# Product Change Notice (PCN)

PCN Number: PCN-0451198R-01

Product(s) Affected: PJ-054

PREVIOUS CUI DEVICES DETAIL / IMAGE	NEW CUI DEVICES DETAIL / IMAGE

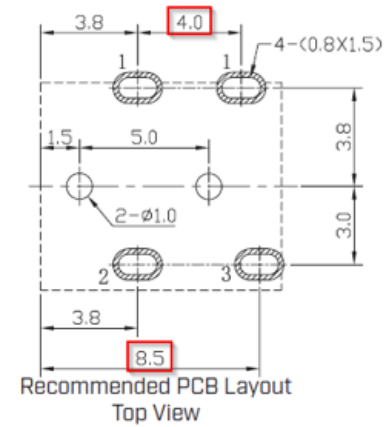
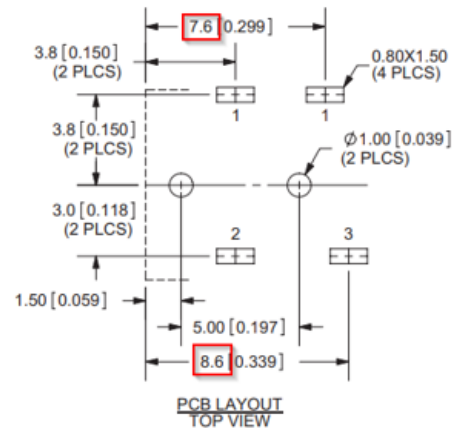
Description of Change: Mechanical, material, and PCB layout changes as noted below.

MATERIAL	PLATING
center pin	brass	nickel
terminal 1	brass	tin
terminal 2	copper alloy	tin
terminal 3	brass	tin
plastic	PA66

DESCRIPTION	MATERIAL	PLATING/COLOR
center pin	H65 brass	nickel
terminal 1	brass	silver
terminal 2	bronze	silver
terminal 3	brass	silver
housing	PA9T [UL94V-0]	black

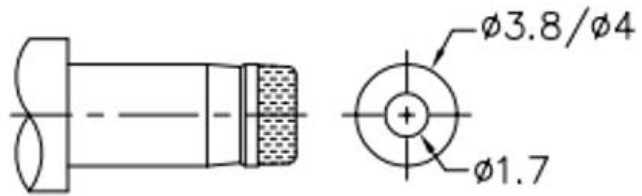
MATING PLUG  
Jack Insertion Depth: **6.2 mm**

MATING PLUG  
Jack Insertion Depth: **6.1 mm**
